Colorado River Basin Regional Water Quality Control Board

DATE: March 22, 2016

SUBJECT: Staff Report: Coachella Valley Salt and Nutrient Management Plan (SNMP)
Workshop

**Coachella Valley
SNMP Management Zones**

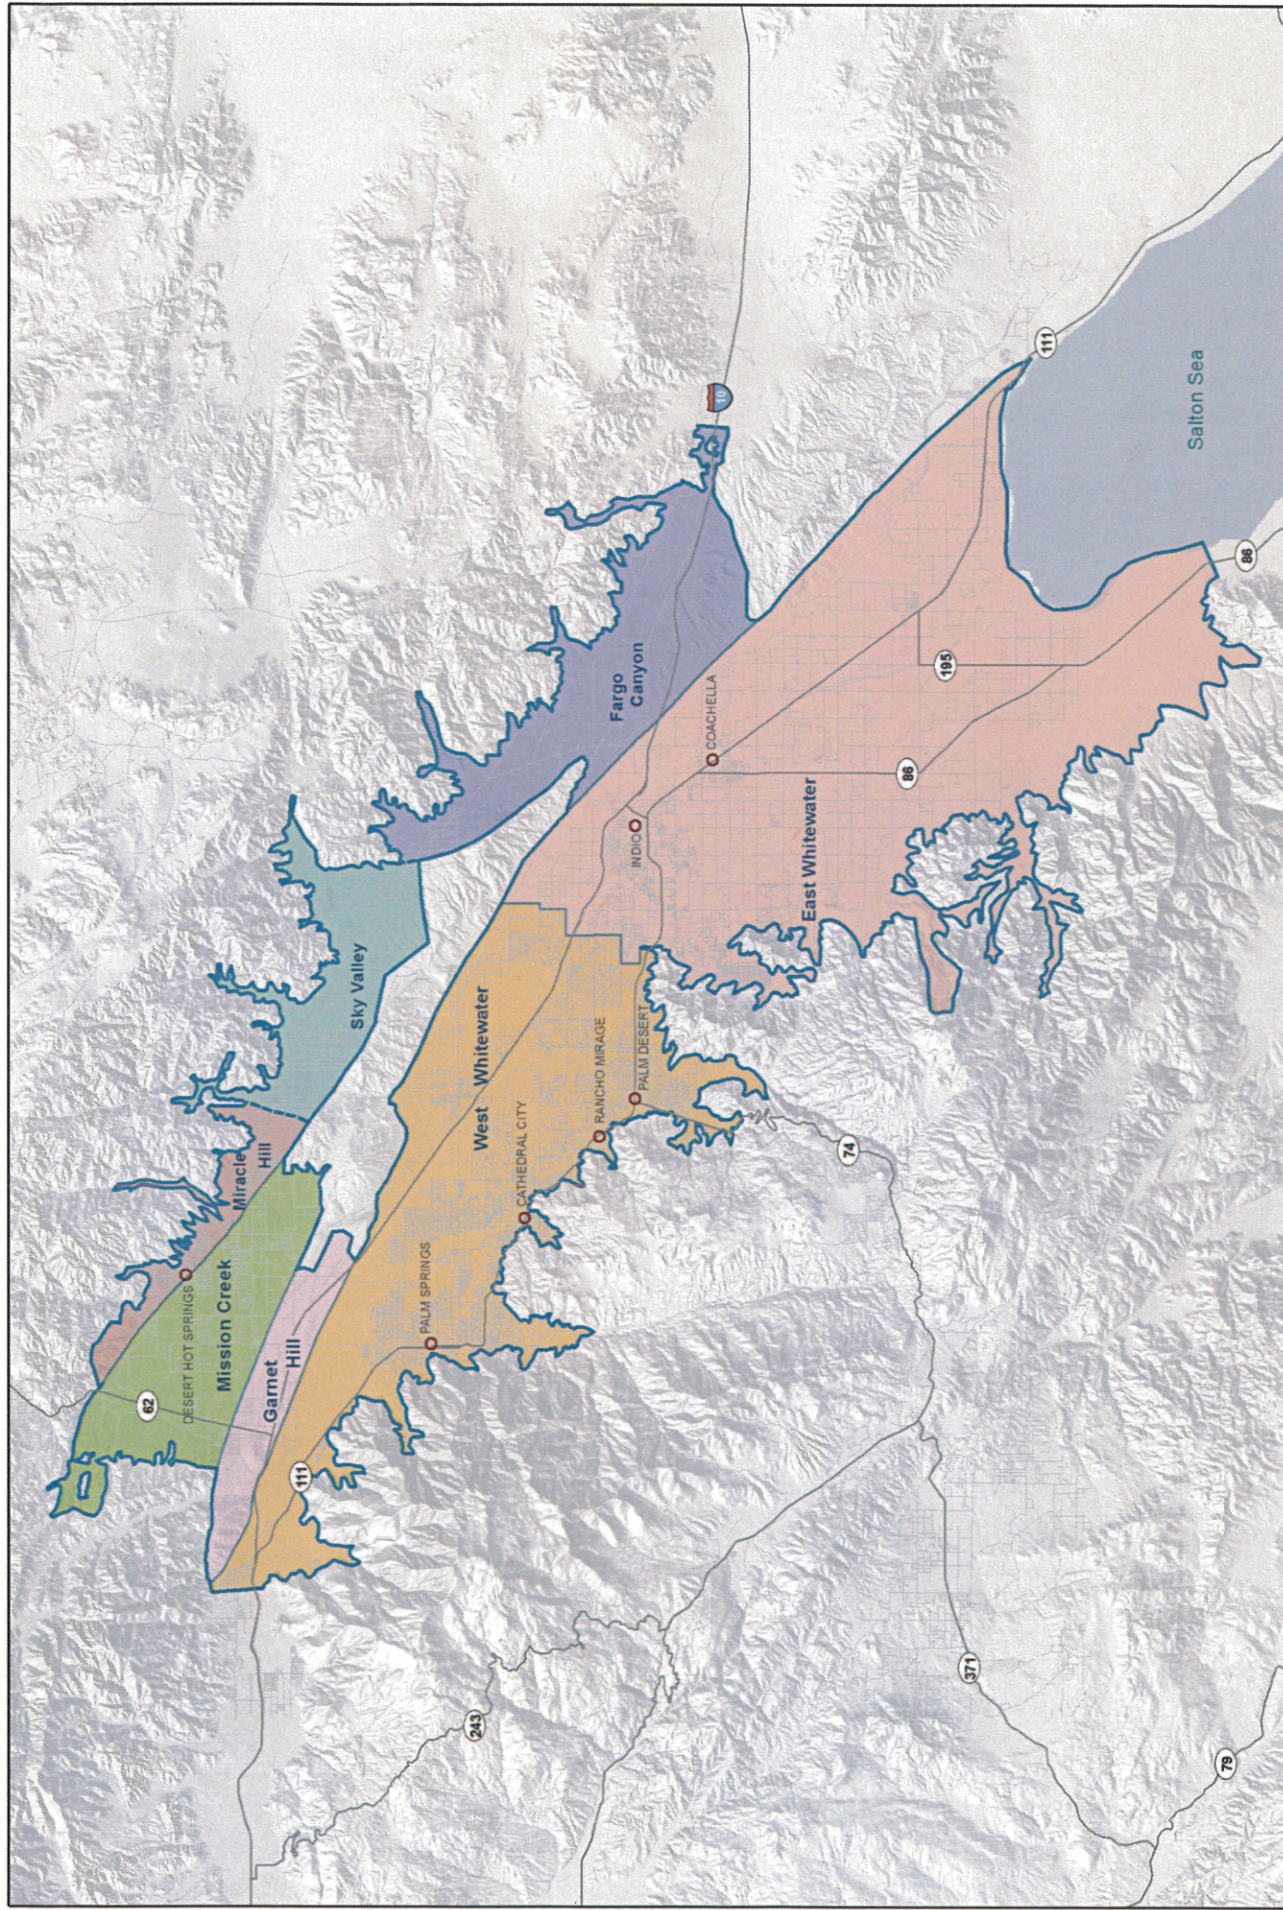
Attachment A shows the MZs. A summary of key components of the CV SNMP are outlined in the following sections.

The proposed CV SNMP is incomplete because it does not establish AWQ for four MZs (MZ4: Garnet Hill, MZ5: Miracle Hill, MZ6: Sky Valley, and MZ7: Fargo Canyon). It is also incomplete because it does not establish Assimilative Capacity for these MZs. Further, it is incomplete because it does not include a monitoring program to establish AWQ and Assimilative Capacity for these MZs. Measures to protect the beneficial uses of the aquifer could not be assessed for these MZs either.
